## **ARCHITECTURAL REVIEW COMMITTEE MEMORANDUM**

DATE: JANUARY 3, 2022 NEW BUSINESS

SUBJECT: ALANA COFFIN, OWNER, REQUESTING A LAND USE PERMIT AND A WAIVER TO CONTINUE THE USE OF AN ENLARGED PARKLET LOCATED AT 368 NORTH PALM CANYON DRIVE, ZONE CBD, (CASE 21-083 LUP). (AP)

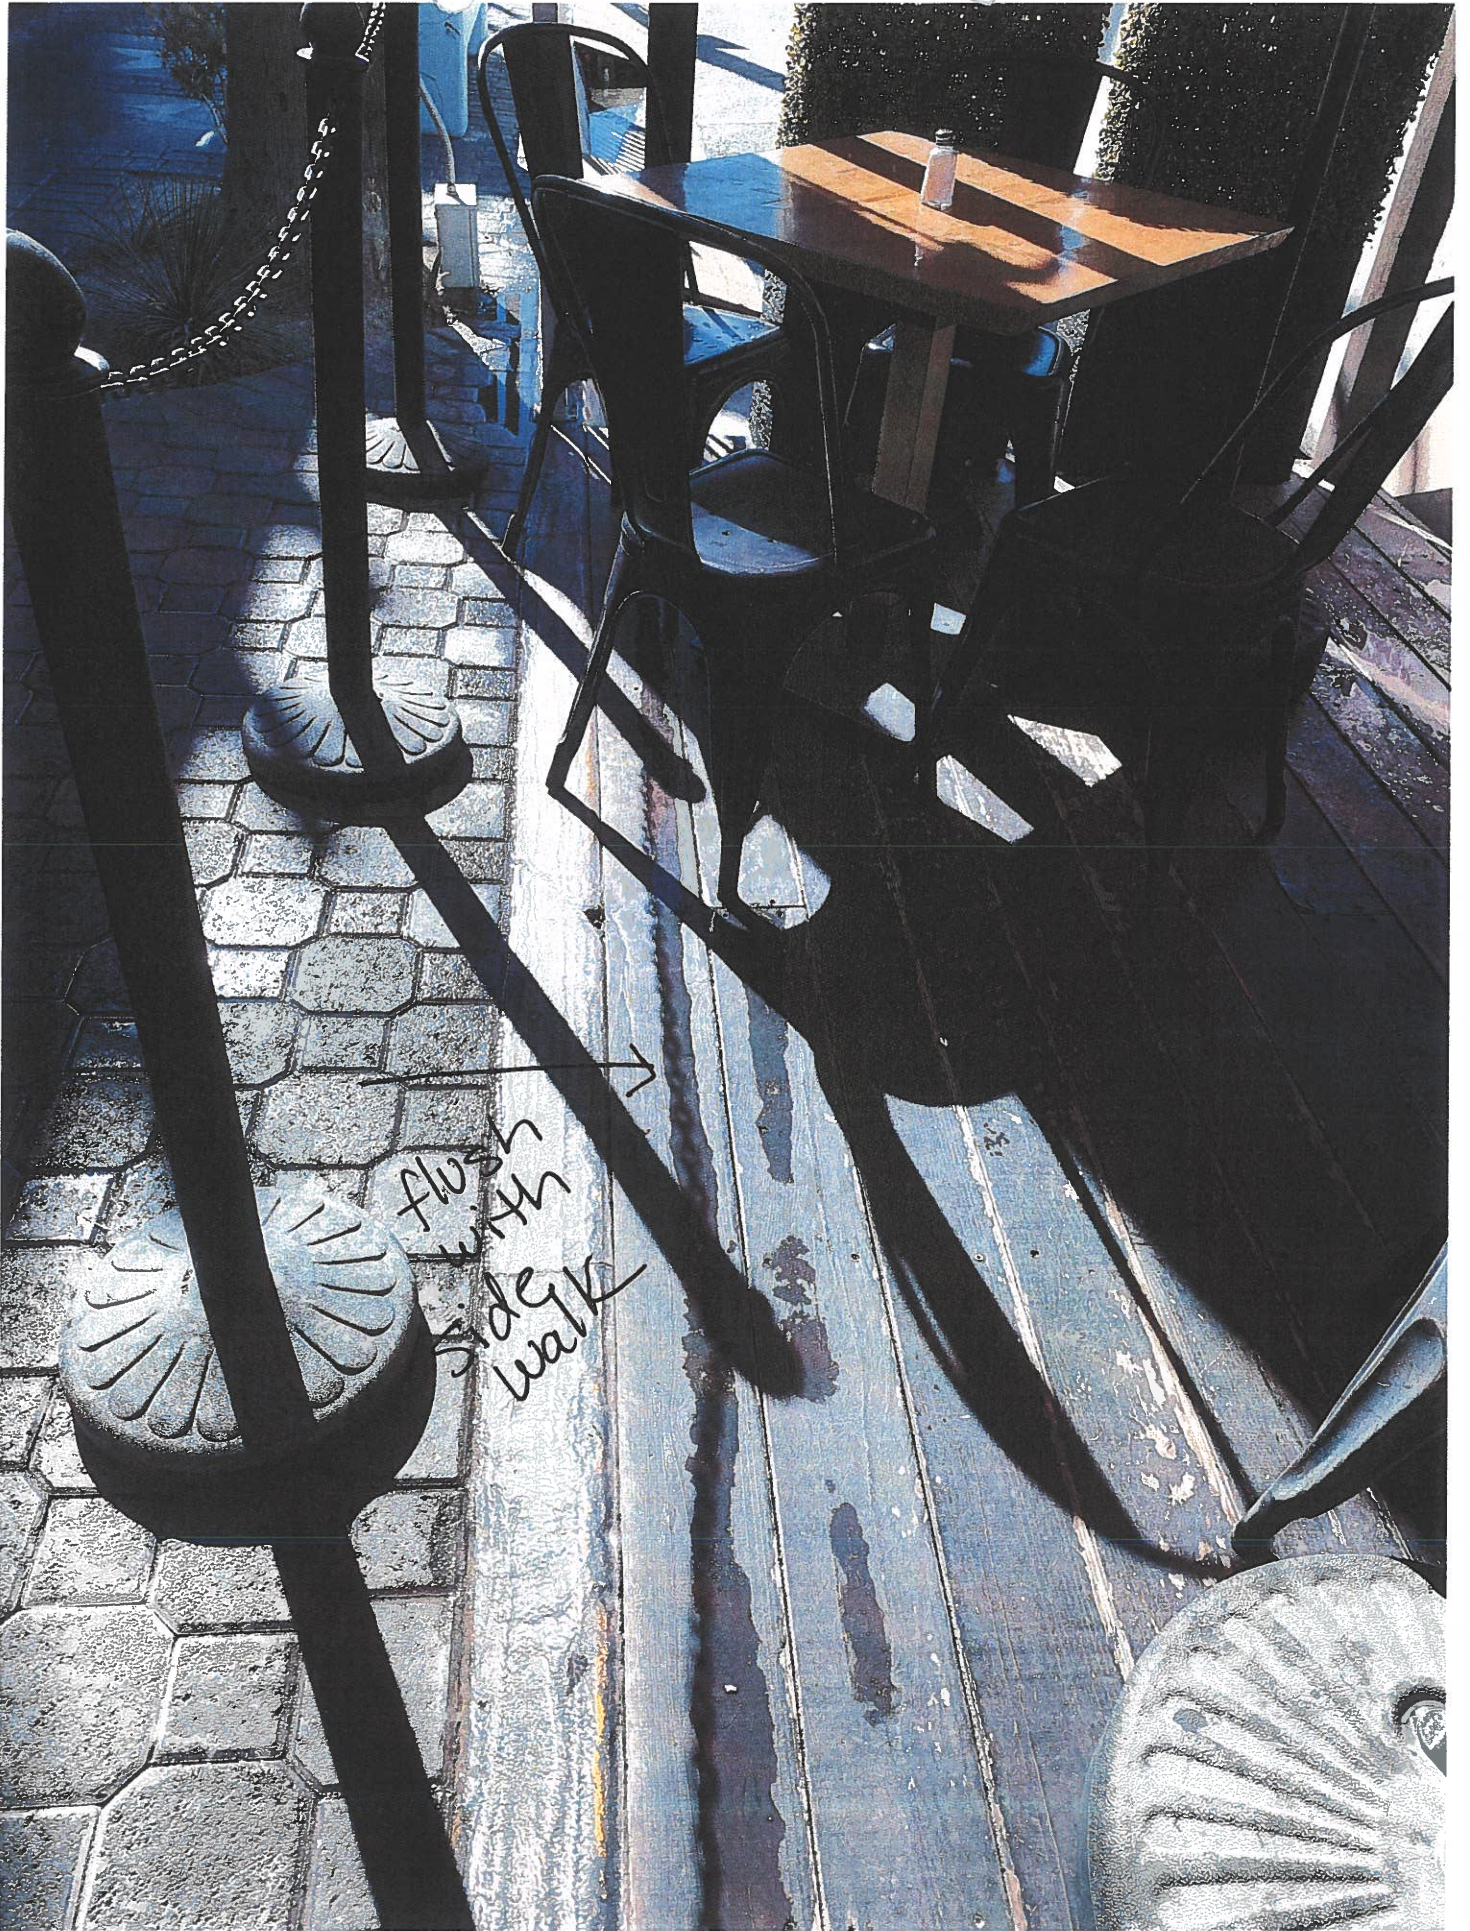
retro reflective tape

permitted colors  
on railing

flush  
with  
side  
walk

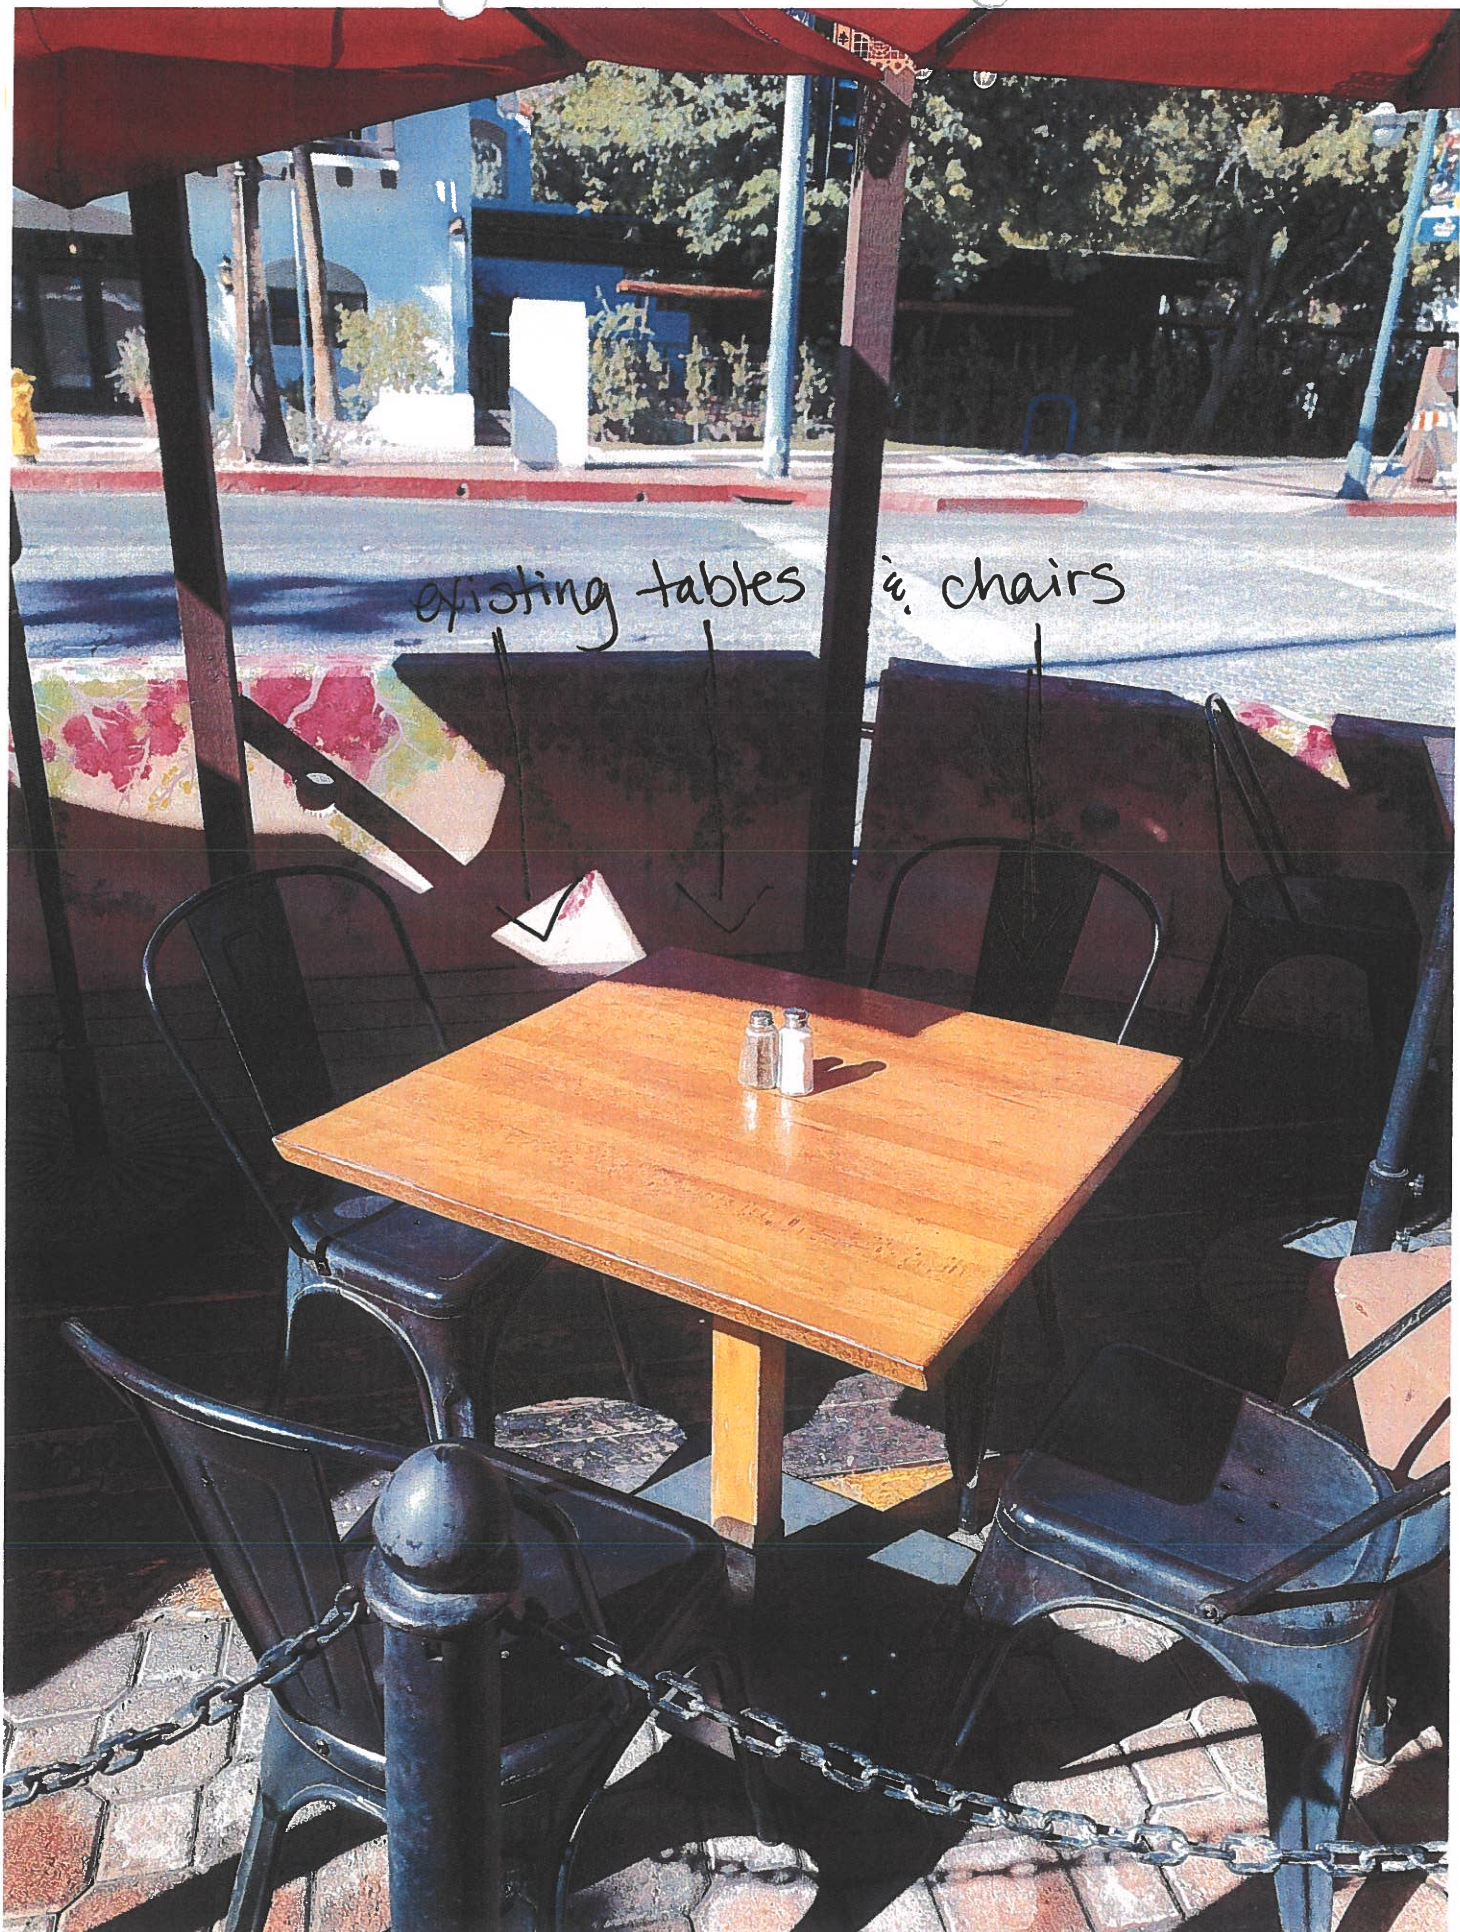
existing tables & chairs

← on street parking space →
